Access Compliance Report Public Rights-of-Way (Curb Ramps)

Intersection ID: 10038458 Main Street: SOUTHERN PINE BV **Cross Street: N/A** Location: NE **ADA ID: 1AFBF056E9F2** Ramp Type: PerpDiag Initial Pass/Fail: Fail **Overall Compliance: No Severity Score:** 25

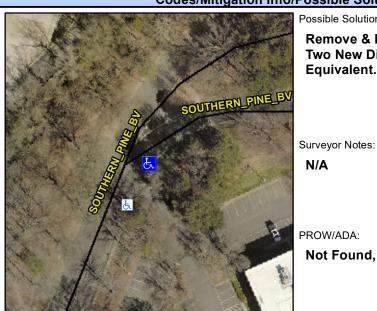
Not Found, R304.2.2

Compliance Description Data Compliance Description Data					
Compliance Description		Data			Data
N/A	Ramp Length (in)	48.0	No	Ramp Slope (%)	14.0
Yes	Ramp Width (in)	48.0	Yes	Ramp XSlope (%)	1.1
N/A	Flare Type LT	N/A	N/A	Flare Type RT	N/A
N/A	Flare Slope LT (%)	N/A	N/A	Flare Slope RT (%)	N/A
N/A	Flare Traversable LT?	N/A	N/A	Flare Traversable RT?	N/A
N/A	Landing Length (in)	N/A	N/A	DWS Provided?	N/A
N/A	Landing Width (in)	N/A	N/A	DWS Contrast?	N/A
N/A	Landing Slope (%)	N/A	N/A	DWS Length (in)	N/A
N/A	Landing X Slope (%)	N/A	N/A	DWS Full Width?	N/A
N/A	Landing Curb? (Y/N)	N/A	N/A	DWS Offset (in)	N/A
N/A	Shared Landing?	N/A			
N/A	Gutter Ponding?	N/A	N/A	Gutter Slope (%)	N/A
N/A	Gutter Lip Ht (in)	N/A	N/A	Gutter X Slope (%)	N/A
N/A	Painted X Walk1?	No	N/A	Painted X Walk2?	No
	X Walk 1 Direction	To W		X Walk 2 Direction	To S
N/A	X Walk 1 Width (in)	N/A	N/A	X Walk 2 Width (in)	N/A
	X Walk 1 Slope (%)	3.4		X Walk 2 Slope (%)	2.4

Possible Solutions: Remove & Replace Curb Ramp With Two New Directional Ramps or Equivalent.
